# SERVICE BULLETIN

## CONVERSION OF P/N 40-414 WHEEL ASSEMBLY TO P/N 40-75P CONFIGURATION

- EFFECTIVITY:** Parker P/N 40-414 Wheel Assemblies.
- APPLICABILITY:** All Cirrus, Model SR20 aircraft equipped with the P/N 40-414 wheel assemblies that are to be upgraded to use P/N 30-52AB brake and P/N 40-75P wheel assemblies.

Figure 1

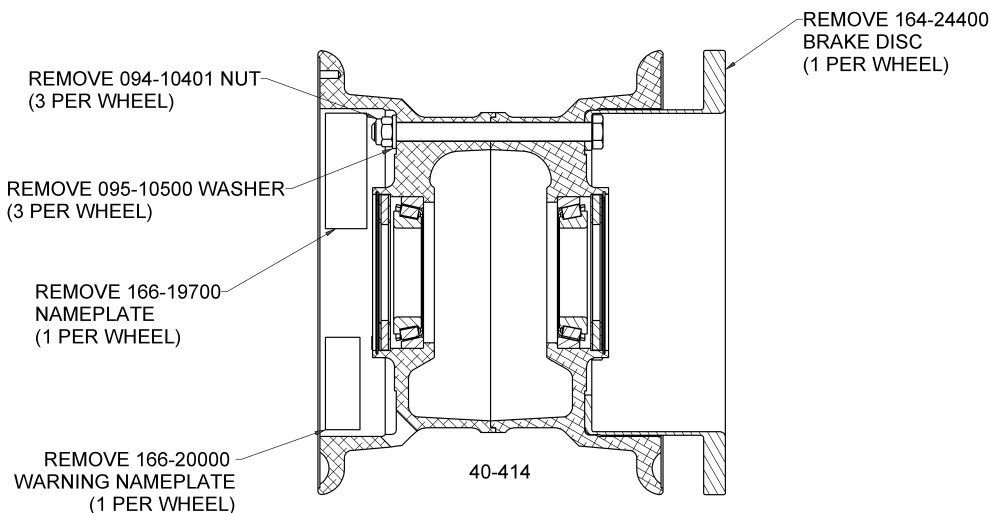
- 1) For new wheels that have not been in service, proceed to step 3.
- 2) Jack aircraft, **DEFLATE** tire and remove valve core, remove wheel IAW Cirrus Design Aircraft maintenance procedures, disassemble wheel, and thoroughly inspect the wheel halves and components ( except as noted in Table 2) for airworthiness IAW Cleveland Wheels & Brakes AWBCMM0001-6 Component Maintenance Manual.
- 3) **DEFLATE** tire and remove valve core, remove and discard the hardware and nameplates as shown in Figure 1 and listed in Table 2 below.

The following components must be removed from the existing P/N 40-414 wheel assembly and discarded. CAUTION: Do not use sharp tool to remove nameplate.

Figure 2

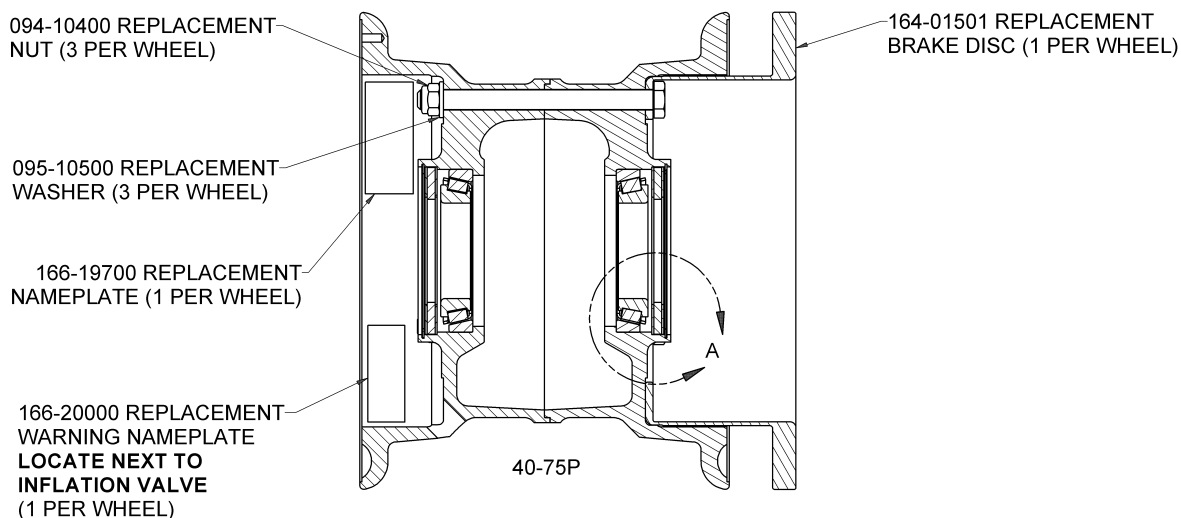
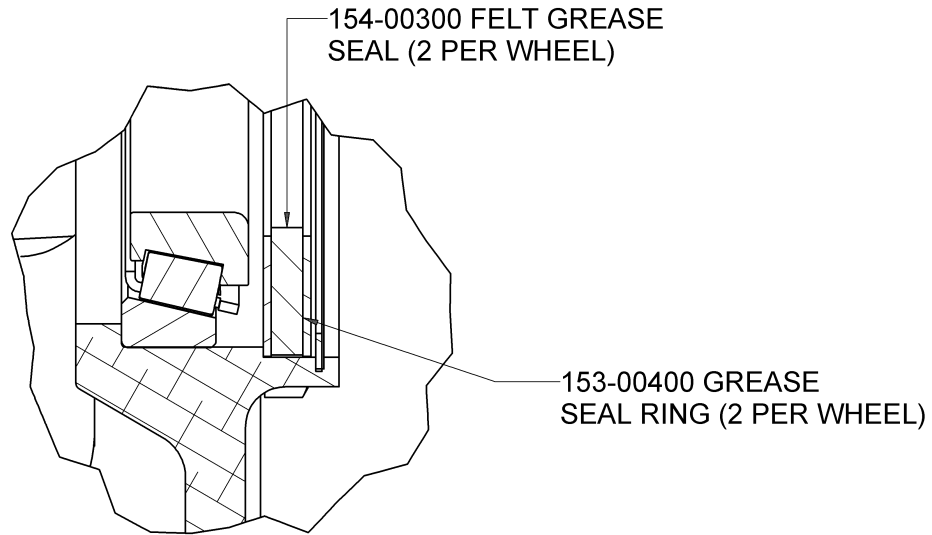
- 4) Disassemble the wheel and inspect components IAW Cleveland Wheel and Brake Component Maintenance Manual, AWBCMM0001-6.
- 5) Assemble the wheel-tire assembly with the hardware listed in SB7084-1 Conversion Kit, (Table 1) IAW Parker AWBCMM0001-6 Component Maintenance Manual and as shown in Figure 2.

7) Apply P/N 166-20000 Warning Nameplate adjacent to the inflation valve hole, Ref. Figure 2.  
Do not apply over existing nameplate. (Two warning nameplates are permissible.)
